KISHENGANGA AND RATLE DAMS' DISPUTE WITH INDIA

MEETING WITH WORLD BANK DELEGATION

MIRZA ASIF BAIG
PAKISTAN COMMISSIONER FOR INDUS WATERS (PCIW)

MAY 2017

INDIA'S DESIGN OF RATLE DAM

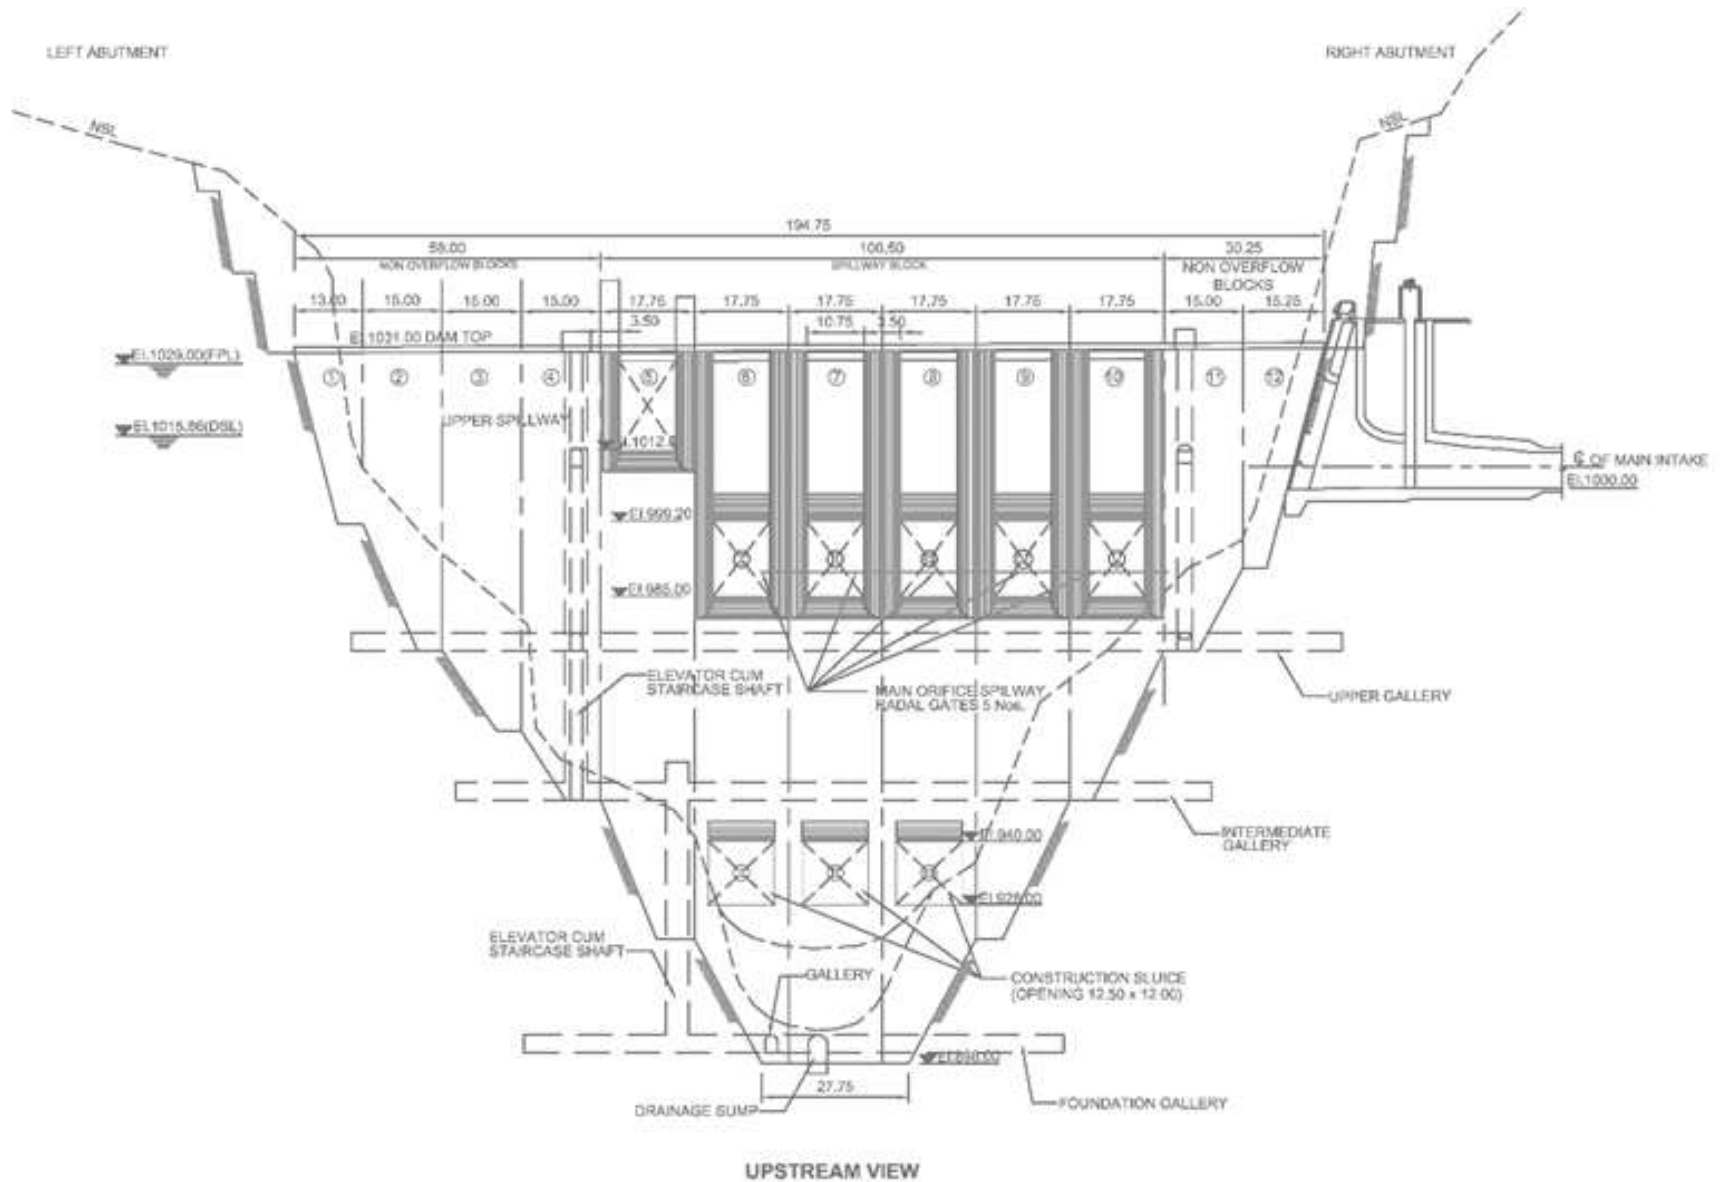
Sr. No.	Project Name	Pakistan's Objections				Spillway Type
		Freeboard	Pondage	Spillway Crest Elevation	Intake Crest Elevation	
1	Ratle	✓	✓	✓	✓	Surface gated + orifice gated
2	Kishenganga		✓	✓	✓	Orifice gated
3	Baglihar	✓	✓	✓	✓	Surface gated + orifice gated
4	Salal			✓		Surface gated
8	Nimo Bazgoo		✓	✓	✓	Orifice gated
9	Lower Kalnai	✓	✓		✓	Surface gated
10	Miyar		✓	✓	✓	Orifice gated
11	Pakaldul	✓	✓	✓		Surface gated + orifice gated
12	Dulhasti

PAKISTAN'S PROPOSED ALTERNATIVE I

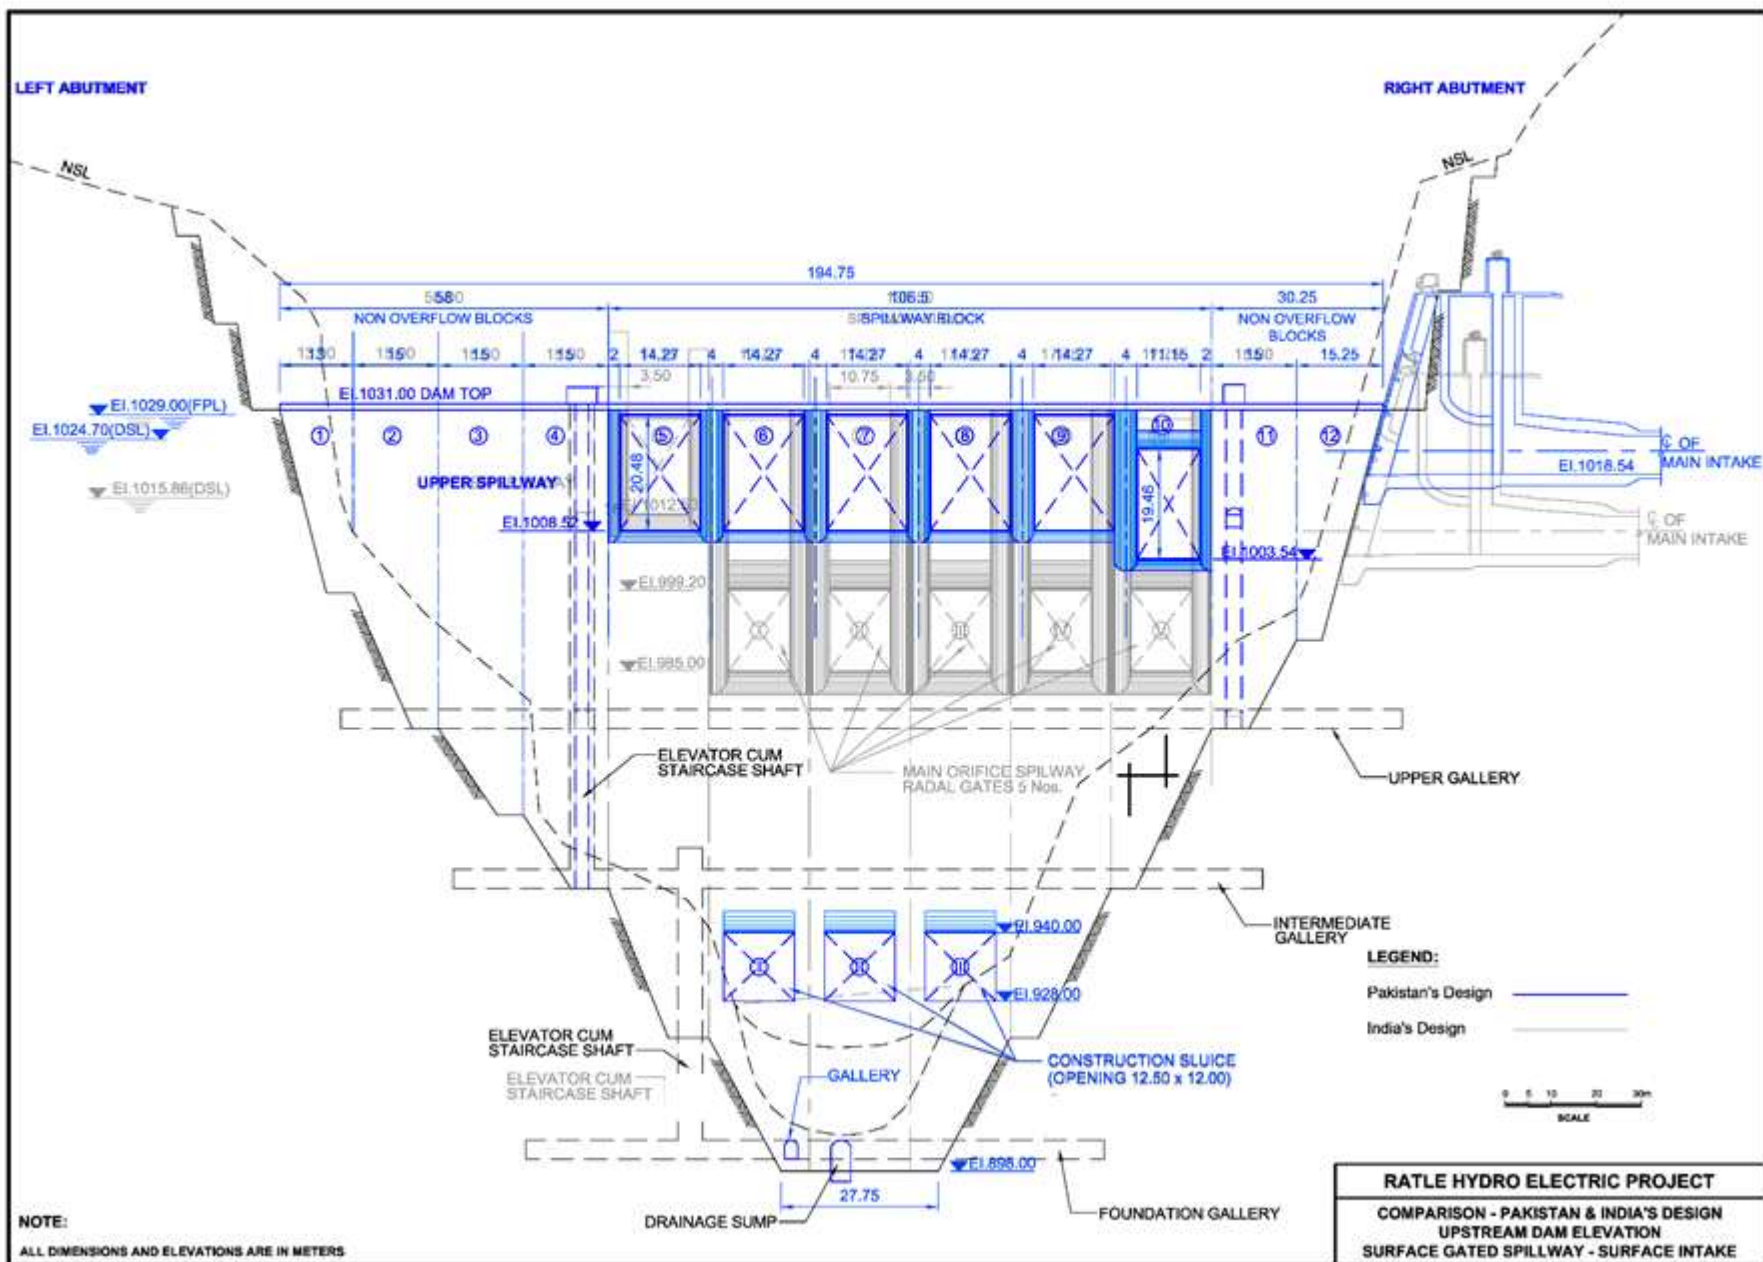
Dam Configuration	Units	India's Design	Pakistan's Proposed Alternative I	Difference
Description	(m ³ /s)	Surface & orifice spillway, submerged intake	Surface & orifice spillway, surface intake	-
Full Pondage Level (FPL)	(m)	1,029.00	1,029.00	
Dead Storage Level (DSL)	(m)	1,015.86	1,024.70	8.84
Pondage	(Mm ³)	23.84	8.10	294%
Crest Level of deepest spillway	(m)	985.00	1,003.54	18.54
Intake Sill Level	(m)	1,000.00	1,018.54	18.54
Concrete Quantity	(m ³)	991,500	852,800	-14%

PAKISTAN'S PROPOSED ALTERNATIVE II

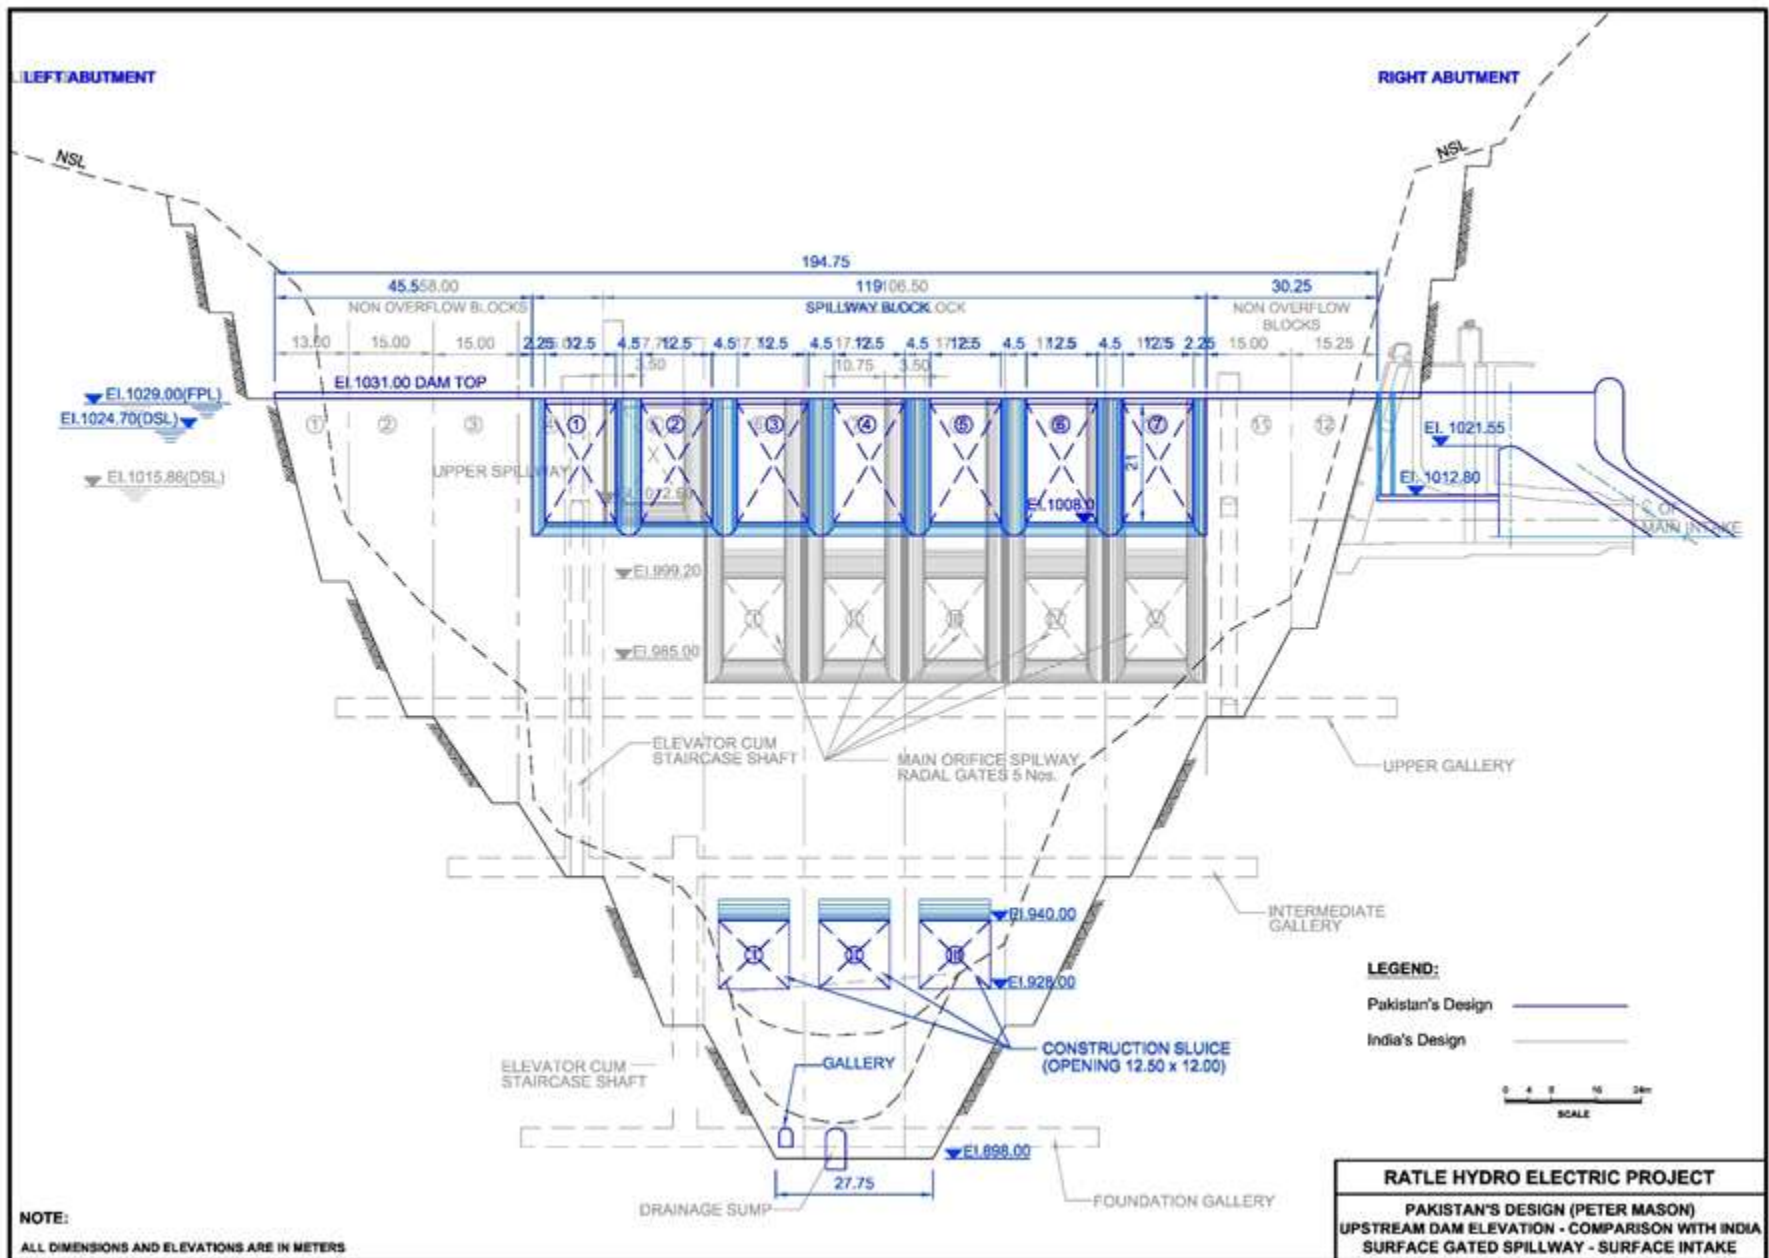
Dam Configuration	Units	India's Design	Pakistan's Proposed Alternative II	Difference
Description	(m ³ /s)	Surface & orifice spillway, submerged intake	Surface spillway, surface intake	-
Full Pondage Level (FPL)	(m)	1,029.00	1,029.00	
Dead Storage Level (DSL)	(m)	1,015.86	1,024.70	8.84
Pondage	(Mm ³)	23.84	8.10	294%
Crest Level of deepest spillway	(m)	985.00	1,008.00	23.00
Intake Sill Level	(m)	1,000.00	1,021.55	21.55
Concrete Quantity	(m ³)	991,500	766,457	-23%

PAKISTAN'S PROPOSED ALTERNATIVE I

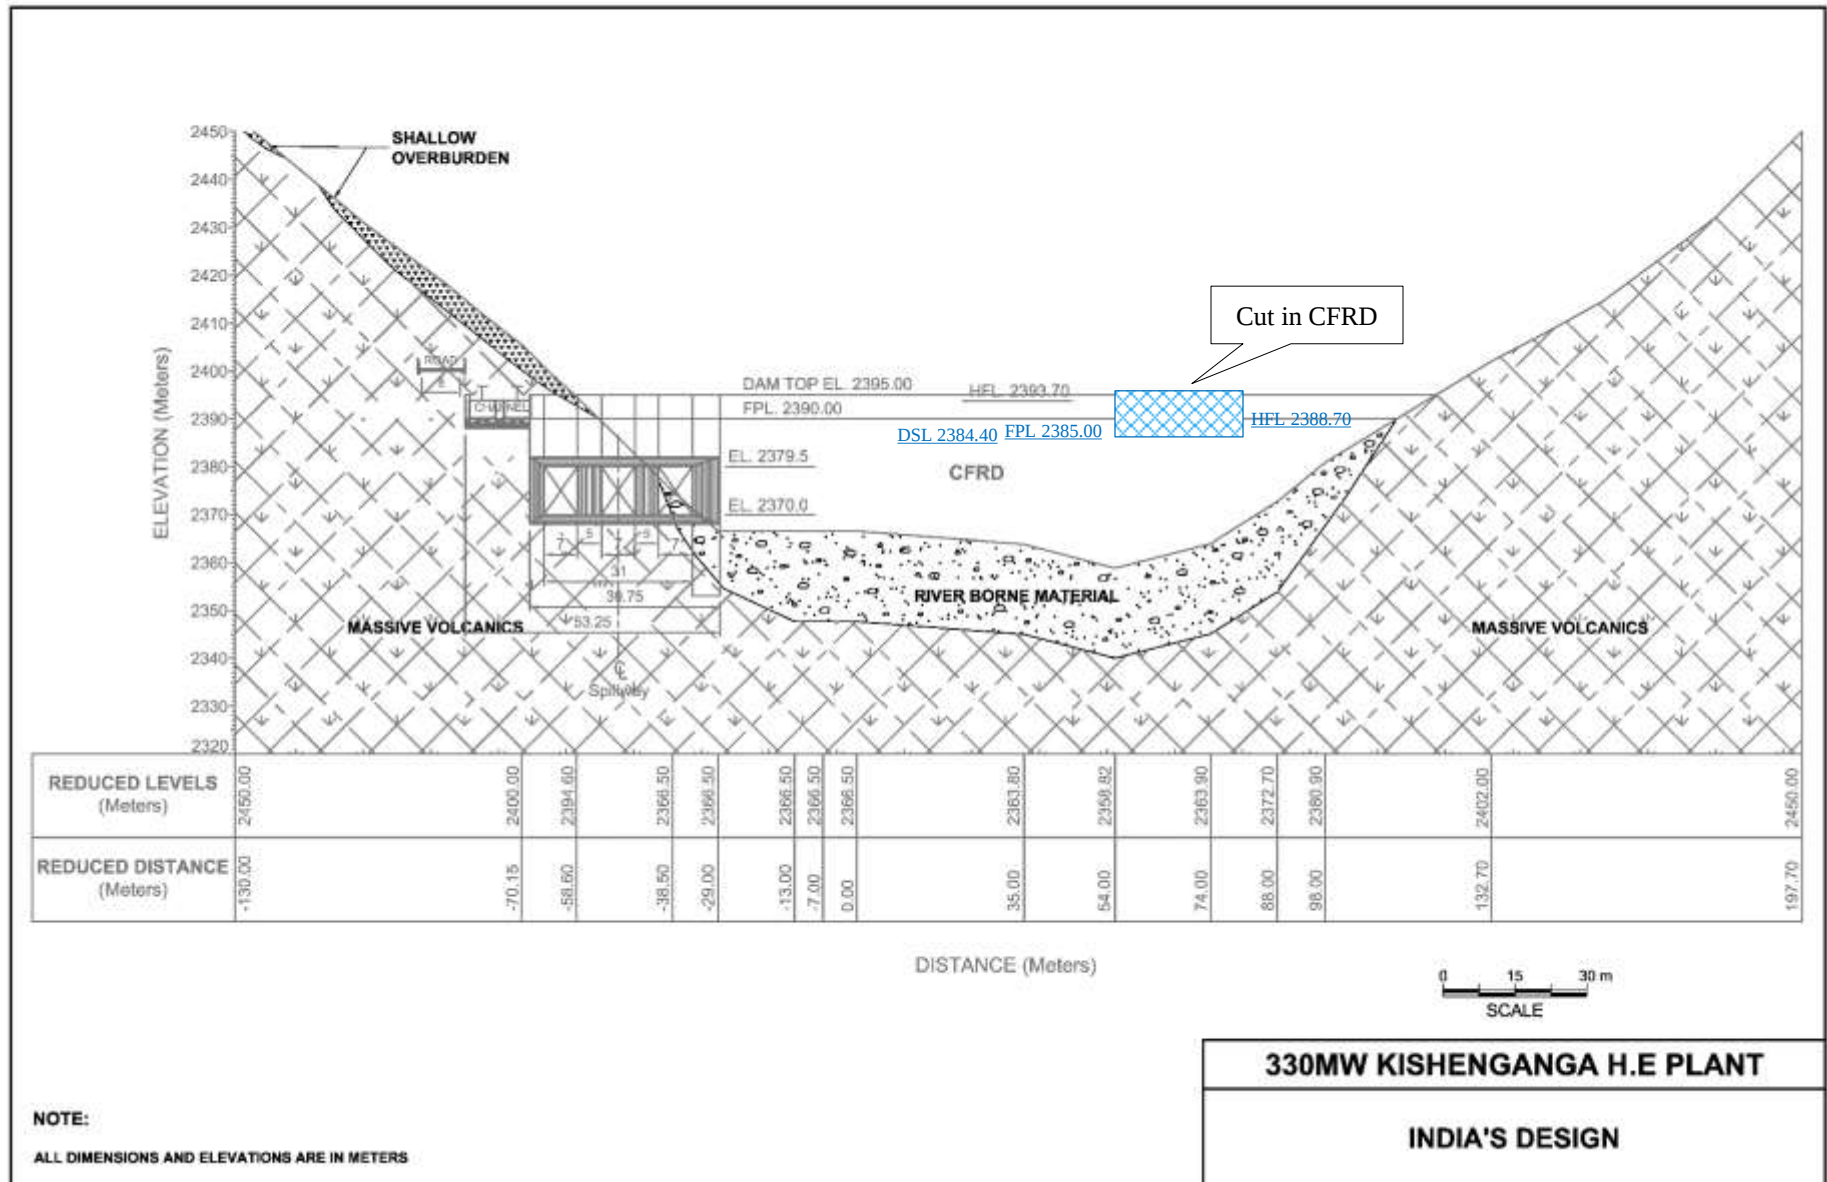
Dam Configuration	Units	India's Design	Pakistan's Proposed Alternative I	Difference
Description	(m ³ /s)	Orifice spillway, submerged intake	Orifice spillway, submerged intake	-
Highest Flood Level (HFL)	(m)	2,393.70	2,388.70	-5.00
Full Pondage Level (FPL)	(m)	2,390.00	2,385.00	-5.00
Dead Storage Level (DSL)	(m)	2,384.50	2,384.40	-0.10
Pondage	(Mm ³)	7.55	1.00	-87%
Crest Level of deepest spillway	(m)	2,370.00	2,370.00	0.00
Intake Sill Level	(m)	2,378.80	2,378.80	0.00
Concrete Quantity	(m ³)	44,800	44,800	0%
FOS (value greater than 1.00 is categorized as safe)	-	2.15	2.15	Safe

PAKISTAN'S PROPOSED ALTERNATIVE III

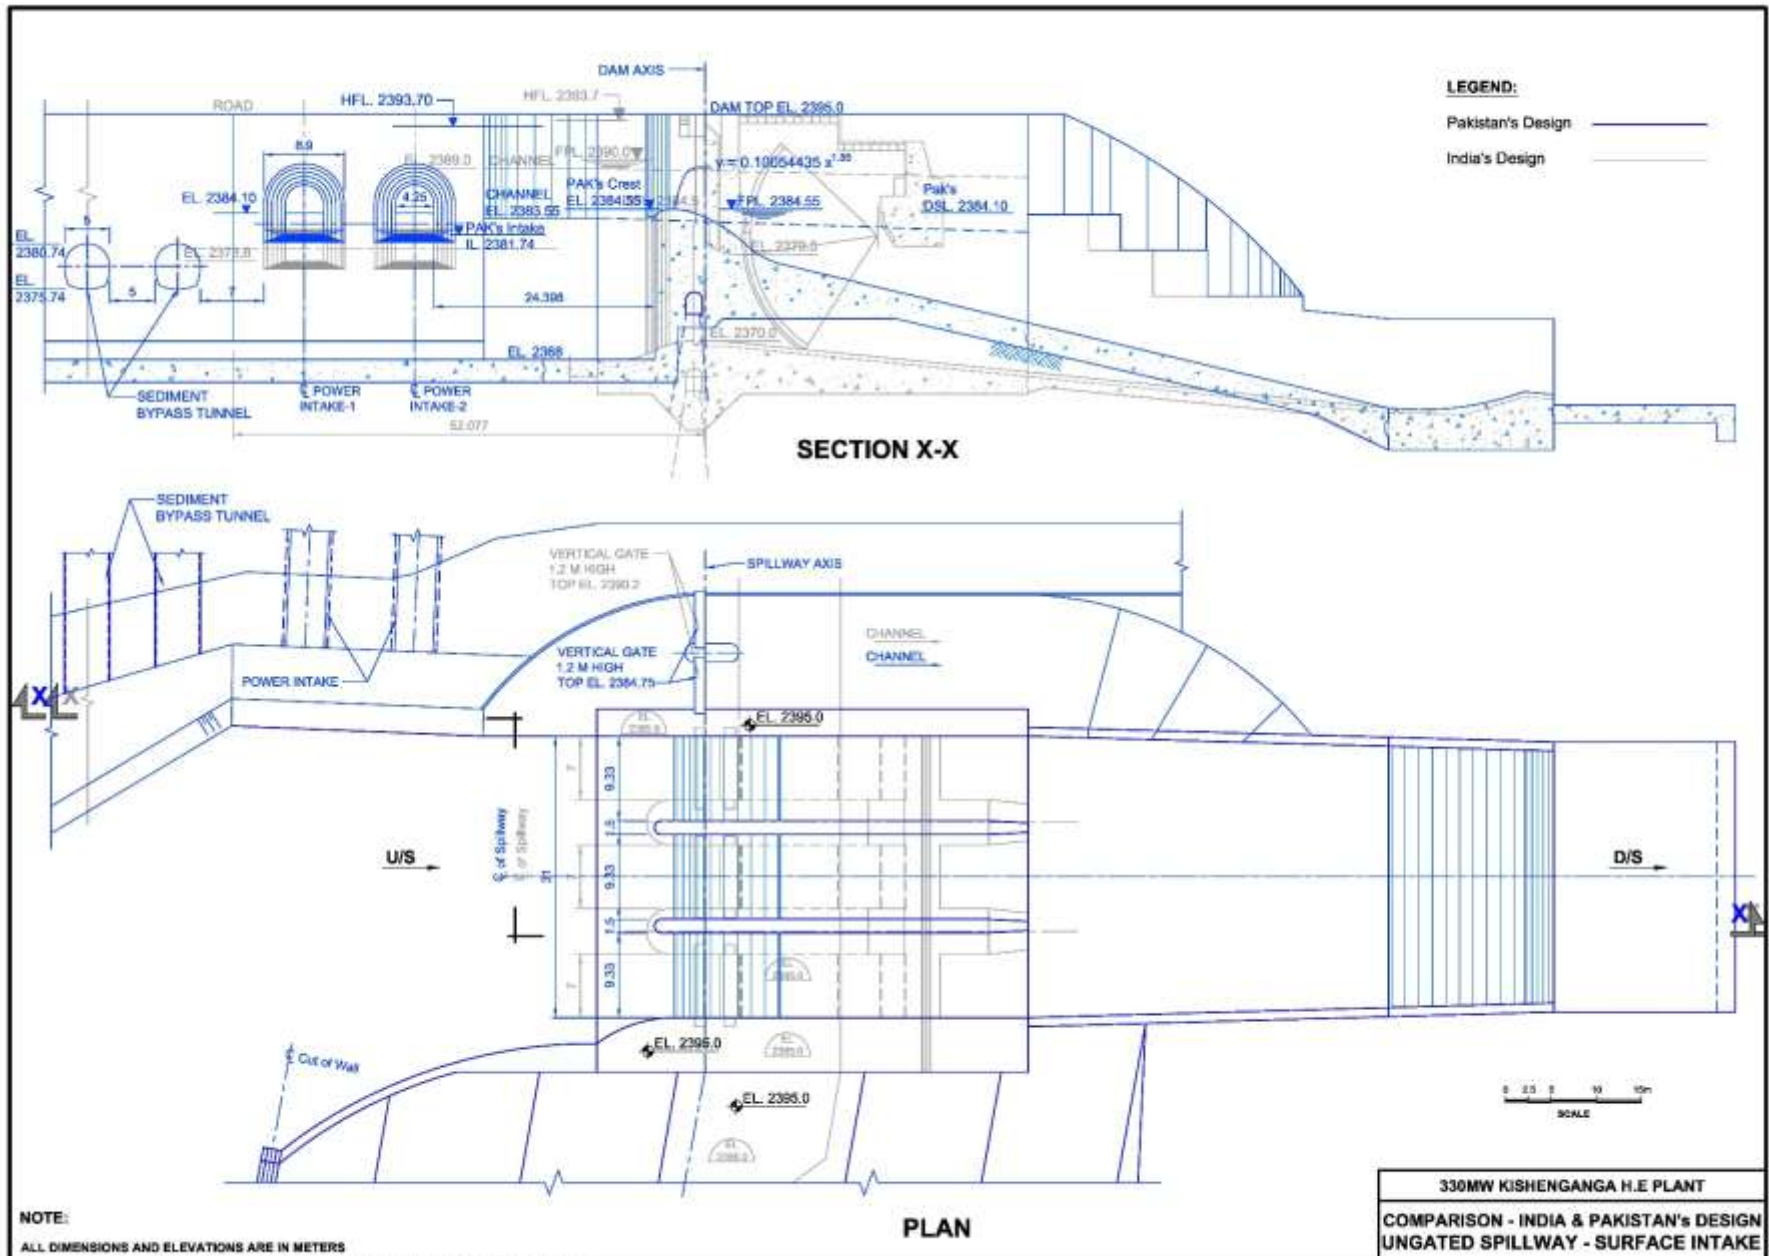
Dam Configuration	Units	India's Design	Pakistan's Proposed Alternative III	Difference
Description	(m ³ /s)	Orifice spillway, submerged intake	ungated spillway, surface intake	-
Highest Flood Level (HFL)	(m)	2,393.70	2,393.70	0.00
Full Pondage Level (FPL)	(m)	2,390.00	2,384.55	-5.45
Dead Storage Level (DSL)	(m)	2,384.50	2,384.10	-0.40
Pondage	(Mm ³)	7.55	1.00	-87%
Crest Level of deepest outlet	(m)	2,370.00	2,375.74	5.74
Intake Sill Level	(m)	2,378.80	2,381.74	2.94
Concrete Quantity	(m ³)	44,800	36,800	-18%
FOS (value greater than 1.00 is categorized as safe)	-	2.15	3.16	Safe
